County of Fresno

North Annex Jail ADA Transition Plan

LARS ANDERSEN & ASSOCIATES, INC.

JUNE 30, 2014

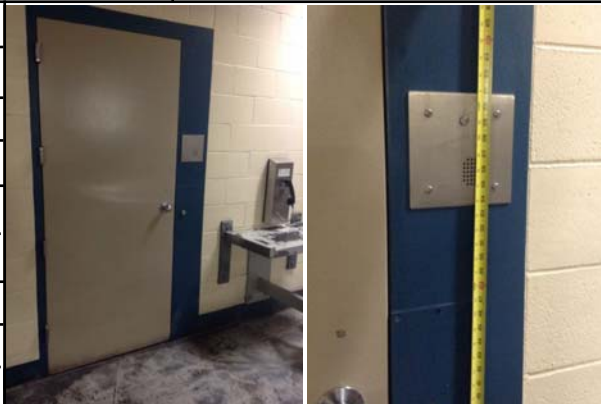
470	North Annex Jail	Priority:	3
Category		Accessories	
Issue		Recommendation	
Mirror over lavatory or countertop measured over 40" AFF to the bottom edge of the reflecting surface		Reset mirror to maximum 40" AFF to reflecting surface	
ADA Reference:			
603.3			
CBC Reference:			
11B-603.3			
Floor:	2nd		
Room:	Infirmery		
Location:	Restroom		
Cost:	2000		
Duration:	10 hrs

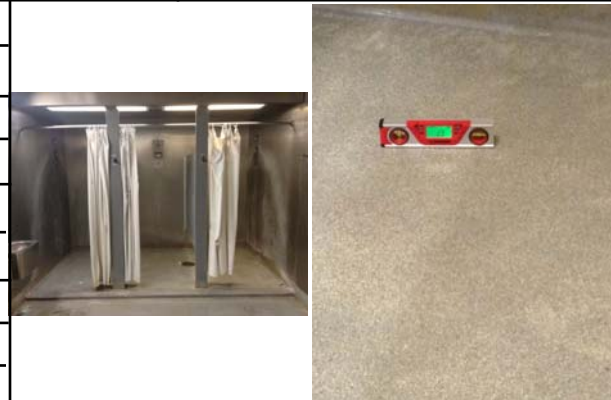
490	North Annex Jail	Priority:	2
Category		Detention Facility Water Closets (ADULT)	
Issue		Recommendation	
Seat height measured less than 17" AFF		Remove and replace water closet per current standards	
ADA Reference:			
604.4			
CBC Reference:			
11B-604.4			
Floor:	3rd		
Room:	Pod-D		
Location:	Upstairs		
Cost:	6000		
Duration:	30 hrs

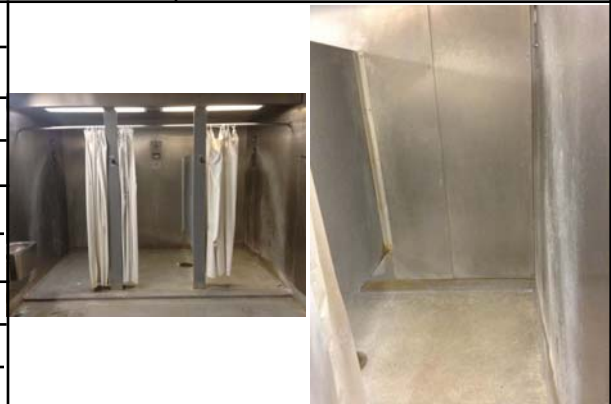
496	North Annex Jail	Priority:	2
Category		Detention Facility Showers	
Issue		Recommendation	
Centerline of water control not 39"-41" above shower floor and top of unit not greater than 48"		Adjust as required	
ADA Reference:			
N/A			
CBC Reference:			
11B-608.5.2			
Floor:	3rd		
Room:	Pod-D		
Location:	Upstairs		
Cost:	See *6		
Duration:	See *6

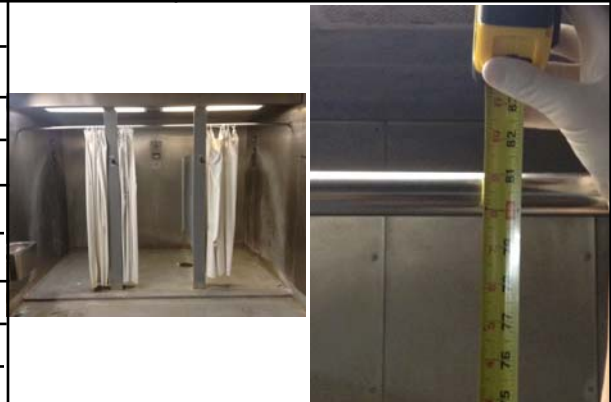
498	North Annex Jail	Priority:	2
Category		Detention Facility Showers	
Issue		Recommendation	
Folding seat not provided		Provide folding seat	
ADA Reference:			
N/A			
CBC Reference:			
11B-610.5			
Floor:	3rd		
Room:	Pod-D		
Location:	Upstairs		
Cost:	See *6		
Duration:	See *6

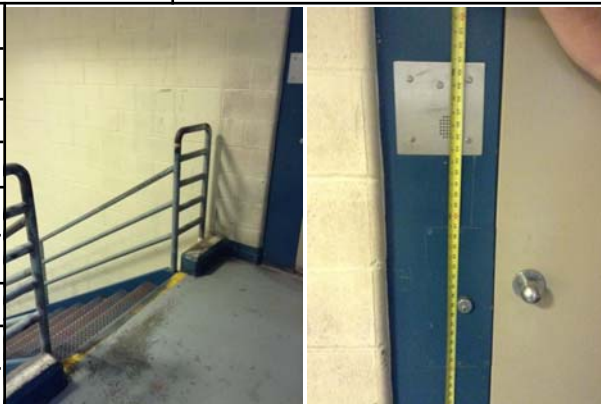
538	North Annex Jail	Priority:	4
Category		Telephones	
Issue		Recommendation	
At least one TTY not provided in a secured area of a correctional facility if a public phone for detainees is provided		Provide accessible TTY per current standards	
ADA Reference:			
217.4.2.2			
CBC Reference:			
11B-217.4.2.2			
Floor:	3rd		
Room:	Pod-F		
Location:			
Cost:	See *6		
Duration:	See *6

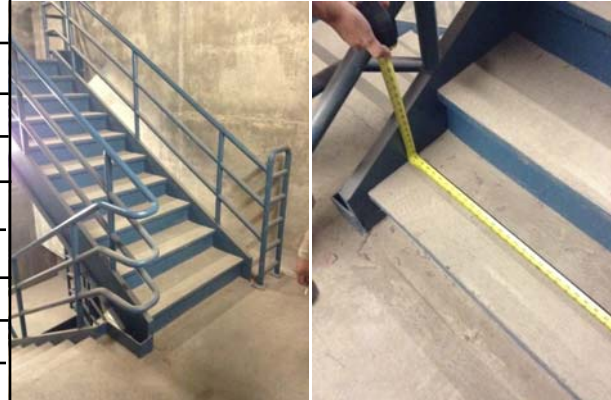
582	North Annex Jail	Priority:	2
Category		Operable parts	
Issue		Recommendation	
Operable part requires tight grasping, pinching or twisting of the wrist		Remove and replace operable part	
ADA Reference:			
309.4			
CBC Reference:			
11B-309.4			
Floor:	4th		
Room:	Infirmery		
Location:	Restroom		
Cost:	See *2		
Duration:	See *2

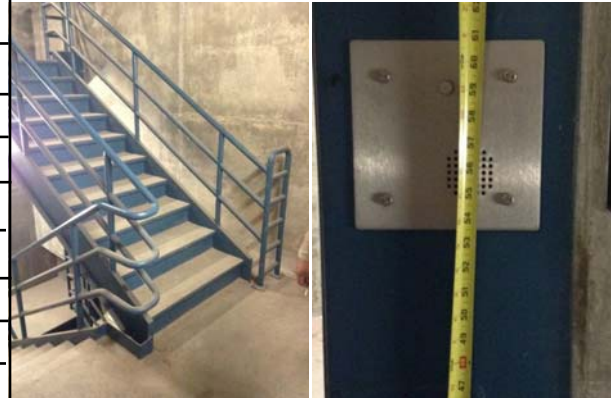
584	North Annex Jail	Priority:	3
Category		Accessories	
Issue		Recommendation	
Toilet paper dispenser not located min. 7" from edge of toilet		Relocate TPD with 7" minimum from edge of toilet	
ADA Reference:			
604.7			
CBC Reference:			
11B-604.7			
Floor:	4th		
Room:	Infirmery		
Location:	Restroom		
Cost:	See *1		
Duration:	See *1

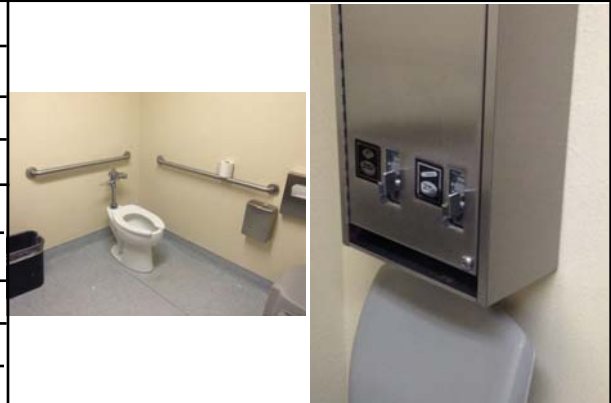
594	North Annex Jail	Priority:	1
Category		Doors / Gates	
Issue		Recommendation	
Door requires over 5 lbs force to open		Adjust closing device	
ADA Reference:			
404.2.9			
CBC Reference:			
11B-404.2.9			
Floor:	4th		
Room:	Staff Restroom		
Location:			
Cost:	300		
Duration:	1.5 hrs

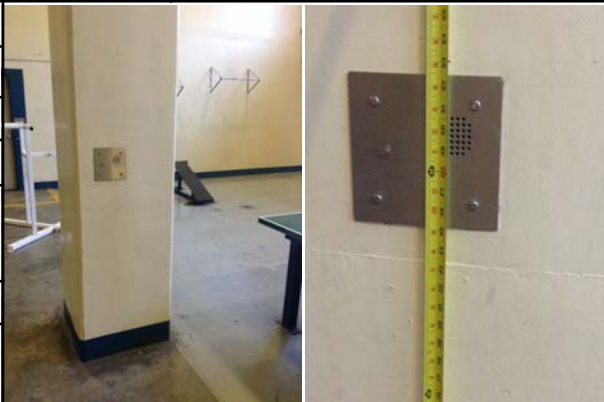
604	North Annex Jail	Priority:	2
Category		Detention Facility Water Closets (ADULT)	
Issue		Recommendation	
Seat height measured less than 17" AFF		Remove and replace water closet per current standards	
ADA Reference:			
604.4			
CBC Reference:			
11B-604.4			
Floor:	4th		
Room:	Gym		
Location:	Restroom		
Cost:	6000		
Duration:	20 hrs

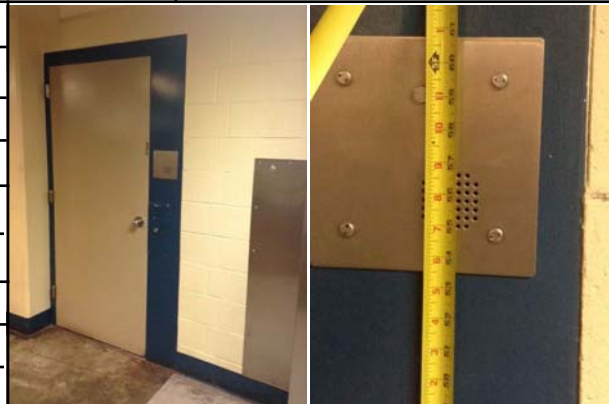
614	North Annex Jail	Priority:	2
Category		Dining/Bar Facilities	
Issue		Recommendation	
Minimum 27" high x 8" deep clearance under counter not provided		Provide minimum 27" high X 8" deep clearance under counter	
ADA Reference:			
902.2			
CBC Reference:			
11B-902.2			
Floor:	4th		
Room:	Classroom		
Location:			
Cost:	See *4		
Duration:	See *4

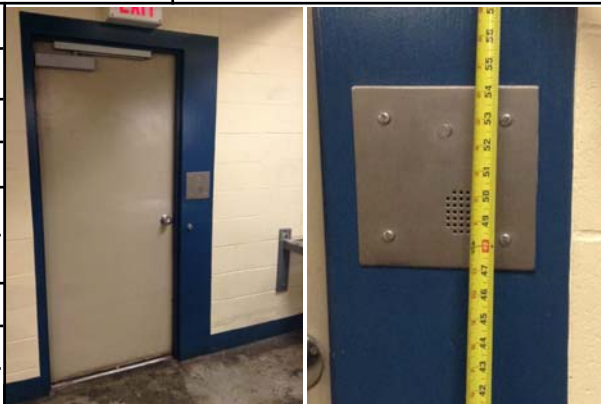
644	North Annex Jail	Priority:	2
Category		Detention Facility Showers	
Issue		Recommendation	
Grab bar not provided on side wall opposite of seat in standard shower		Provide new bar per current standards	
ADA Reference:			
608.3.2			
CBC Reference:			
11B-608.3.2			
Floor:	4th		
Room:	Pod-A		
Location:	Upstairs		
Cost:	See *6		
Duration:	See *6

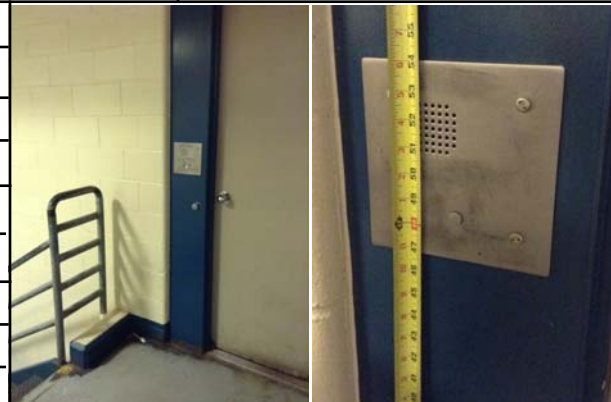
647	North Annex Jail	Priority:	2
Category		Dining/Bar Facilities	
Issue		Recommendation	
Required 30" by 48" clear floor space not provided at accessible seating spaces		Provide required clear floor space at accessible seating	
ADA Reference:			
902.2			
CBC Reference:			
11B-902.2			
Floor:	4th		
Room:	Pod-B		
Location:			
Cost:	See *6		
Duration:	See *6

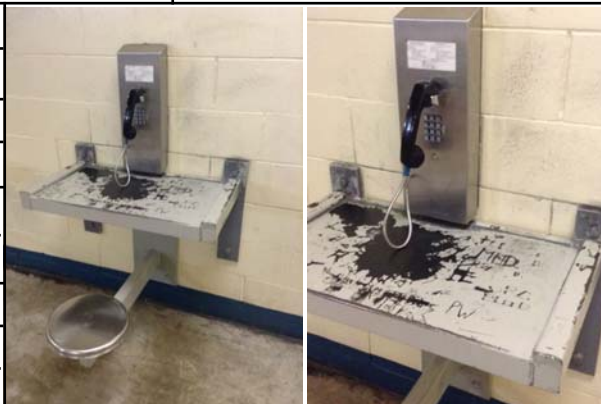
653	North Annex Jail	Priority:	2
Category		Reach Range	
Issue		Recommendation	
Maximum 48" AFF reach range exceeded /(forward unobstructed reach, 10" maximum reach depth)		Provide required reach range	
ADA Reference:			
308.2.1			
CBC Reference:			
11B-308.2.1			
Floor:	4th		
Room:	Pod-B		
Location:	Upstairs		
Cost:	See *6		
Duration:	See *6

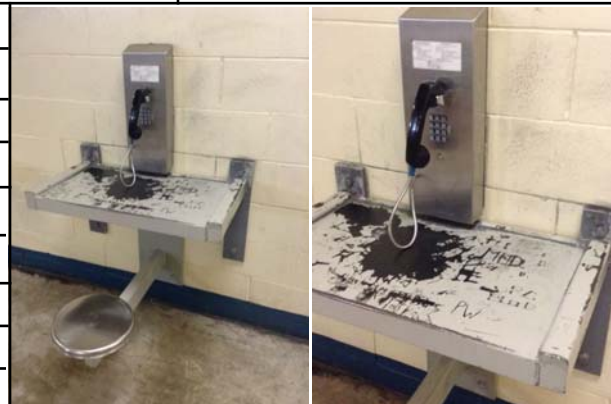
654	North Annex Jail	Priority:	1
Category		Stairs	
Issue		Recommendation	
Extension of handrail at top stairs not 12" minimum of level distance (parallel with floor) beyond top nosing		Modify handrail(s) to provide required 12" extensions or replace per current standards	
ADA Reference:			
505.10.2			
CBC Reference:			
11B-505.10.2			
Floor:	4th		
Room:	Pod-B		
Location:	Upstairs		
Cost:	See *6		
Duration:	See *6

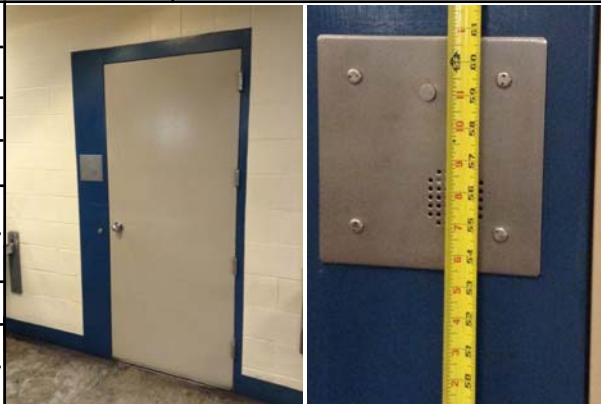
675	North Annex Jail	Priority:	2
Category		Detention Facility Showers	
Issue		Recommendation	
Grab bar not provided on side wall opposite of seat in standard shower		Provide new bar per current standards	
ADA Reference:			
608.3.2			
CBC Reference:			
11B-608.3.2			
Floor:	4th		
Room:	Pod-B		
Location:	Upstairs		
Cost:	See *6		
Duration:	See *6

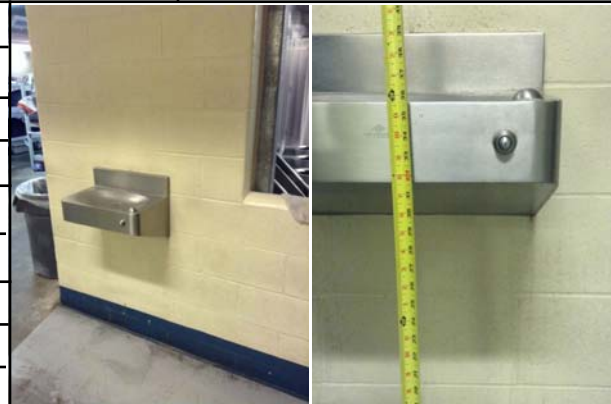
680	North Annex Jail	Priority:	2
Category		Reach Range	
Issue		Recommendation	
Maximum 48" AFF reach range exceeded /(forward unobstructed reach, 10" maximum reach depth)		Provide required reach range	
ADA Reference:			
308.2.1			
CBC Reference:			
11B-308.2.1			
Floor:	4th		
Room:	Pod-C		
Location:			
Cost:	See *6		
Duration:	See *6

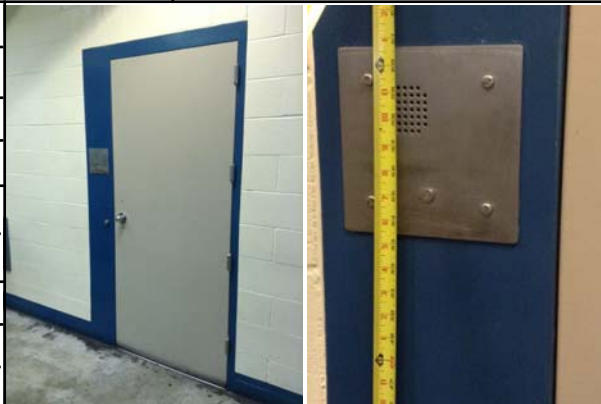
684	North Annex Jail	Priority:	2
Category		Reach Range	
Issue		Recommendation	
Maximum 48" AFF reach range exceeded /(forward unobstructed reach, 10" maximum reach depth)		Provide required reach range	
ADA Reference:			
308.2.1			
CBC Reference:			
11B-308.2.1			
Floor:	4th		
Room:	Pod-C		
Location:	Upstairs		
Cost:	See *6		
Duration:	See *6

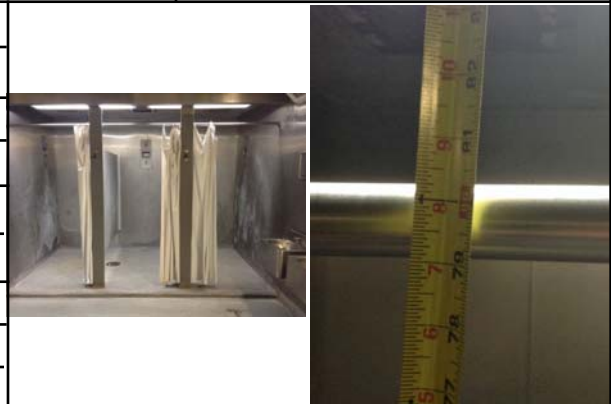
759	North Annex Jail	Priority:	2
Category		Detention Facility Water Closets (ADULT)	
Issue		Recommendation	
Seat height measured less than 17" AFF		Remove and replace water closet per current standards	
ADA Reference:			
604.4			
CBC Reference:			
11B-604.4			
Floor:	4th		
Room:	Pod-E		
Location:	Upstairs		
Cost:	See *6		
Duration:	See *6

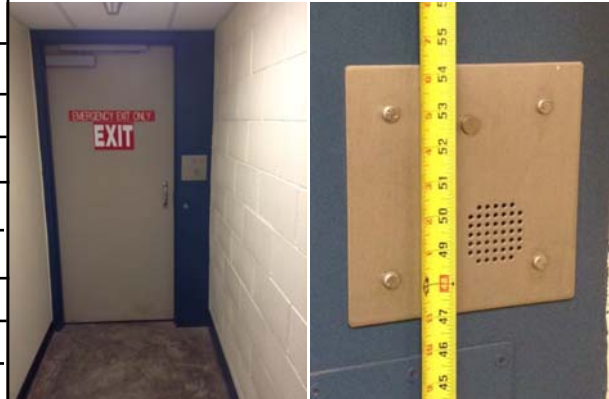
818	North Annex Jail	Priority:	3
Category		Water Closet Compartments (GENERAL)	
Issue		Recommendation	
Water closet compartment not 48" long for maneuvering for end opening door in front of toilet		Provide required clearance or provide alternative accessible water closet	
ADA Reference:			
N/A			
CBC Reference:			
11B-604.8.1.1.3			
Floor:	5th		
Room:	Infirmary		
Location:	Restroom		
Cost:	See *6		
Duration:	See *6

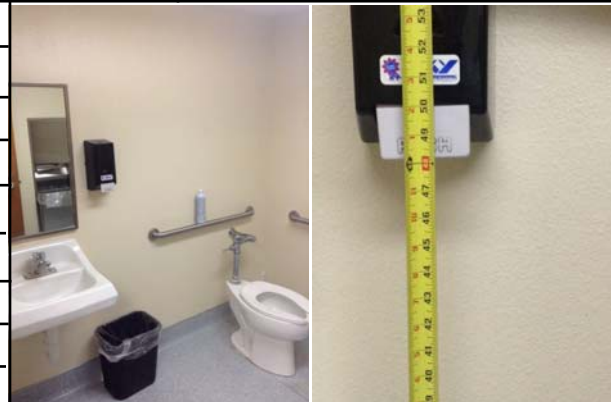
842	North Annex Jail	Priority:	2
Category		Reach Range	
Issue		Recommendation	
Maximum 48" AFF reach range exceeded /(forward unobstructed reach, 10" maximum reach depth)		Provide required reach range	
ADA Reference:			
308.2.1			
CBC Reference:			
11B-308.2.1			
Floor:	5th		
Room:	Southwest		
Location:			
Cost:	See *7		
Duration:	See *7

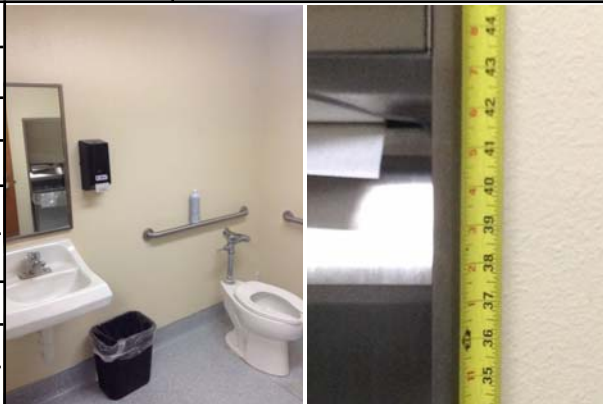
843	North Annex Jail	Priority:	2
Category		Dining/Bar Facilities	
Issue		Recommendation	
Minimum 27" high x 8" deep clearance under counter not provided		Provide minimum 27" high X 8" deep clearance under counter	
ADA Reference:			
902.2			
CBC Reference:			
11B-902.2			
Floor:	5th		
Room:	Classroom		
Location:			
Cost:	See *7		
Duration:	See *7

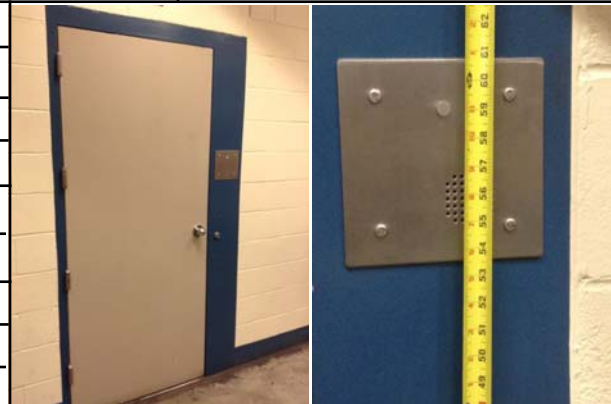
956	North Annex Jail	Priority:	1
Category		Stairs	
Issue		Recommendation	
Extension of handrail at top stairs not 12" minimum of level distance (parallel with floor) beyond top nosing		Modify handrail(s) to provide required 12" extensions or replace per current standards	
ADA Reference:			
505.10.2			
CBC Reference:			
11B-505.10.2			
Floor:	5th		
Room:	Pod-D		
Location:	Upstairs		
Cost:	See *6		
Duration:	See *6

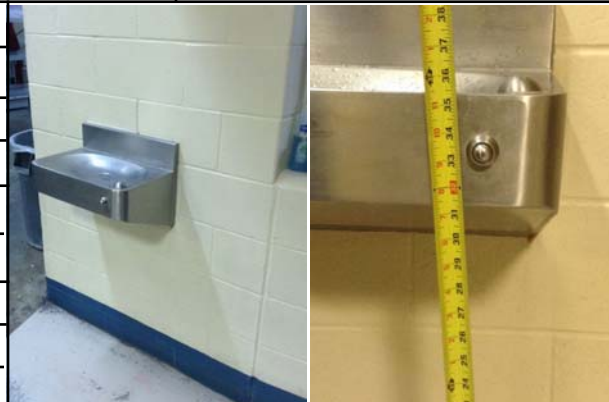
984	North Annex Jail	Priority:	4
Category		Telephones	
Issue		Recommendation	
At least one TTY not provided in a secured area of a correctional facility if a public phone for detainees is provided		Provide accessible TTY per current standards	
ADA Reference:			
217.4.2.2			
CBC Reference:			
11B-217.4.2.2			
Floor:	5th		
Room:	Pod-E		
Location:			
Cost:	See *6		
Duration:	See *6

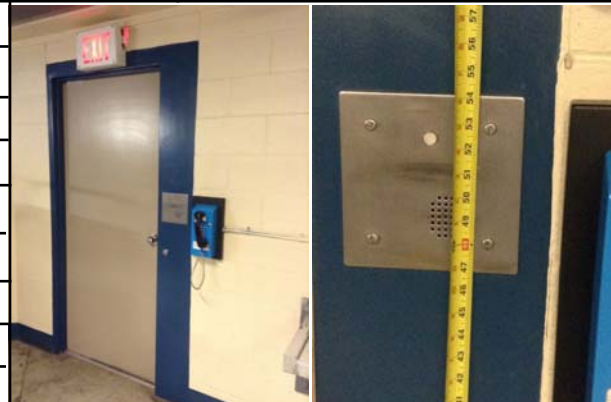
1011	North Annex Jail	Priority:	2
Category		Detention Facility Showers	
Issue		Recommendation	
Grab bar not provided on side wall opposite of seat in standard shower		Provide new bar per current standards	
ADA Reference:			
608.3.2			
CBC Reference:			
11B-608.3.2			
Floor:	5th		
Room:	Pod-E		
Location:	Upstairs		
Cost:	6000		
Duration:	30 hrs

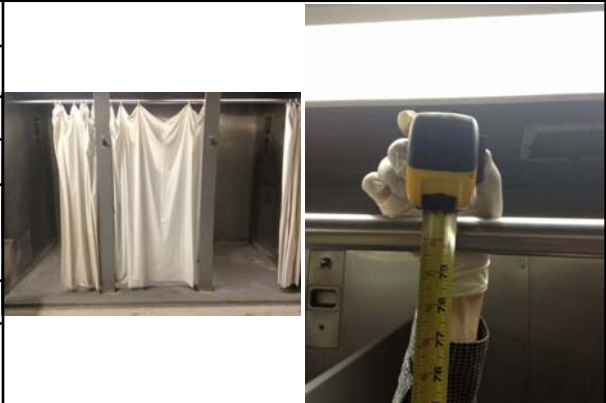
1038	North Annex Jail	Priority:	2
Category		Detention Facility Showers	
Issue		Recommendation	
Threshold into shower greater than 1/2" height		Provide transition into shower	
ADA Reference:			
608.7			
CBC Reference:			
11B-608.7			
Floor:	5th		
Room:	Pod-F		
Location:	Upstairs		
Cost:	See *6		
Duration:	See *6
